Pawnee Mesa
file

TO: Ad Hoc Drainage Committee	PROJECT NO. _____
File	PROJECT: Drainage Criteria
ATTN: _____	DATE: September 10, 1979

Re: Drainage Criteria

**Re: S/D 79-20 - Final plat of Pawnee Mesa Addition -
Appeal of drainage requirements**

STORM WATER CARRYING CAPACITY OF STREETS
FOR TWO YEAR AND HUNDRED YEAR STORMS

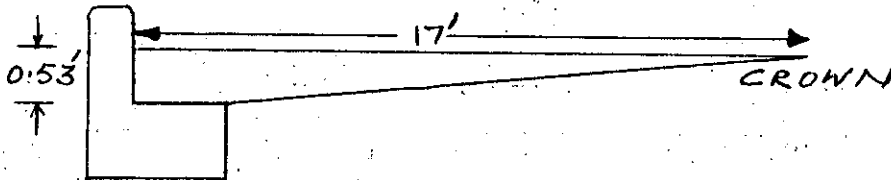
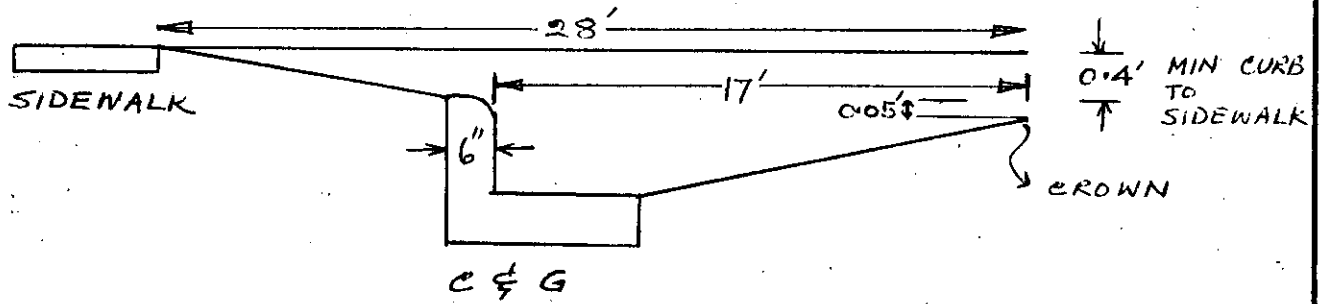
Should use a combined n for paved st & grassed R/W. n ≈ .021

} 100yr flow?

Use $n = .03$ and no reduction factor

$$Q_{100} = 900 \times S^{1/2}$$

at $S = .32\%$ $Q_{100} \approx 51 \text{ cfs}$
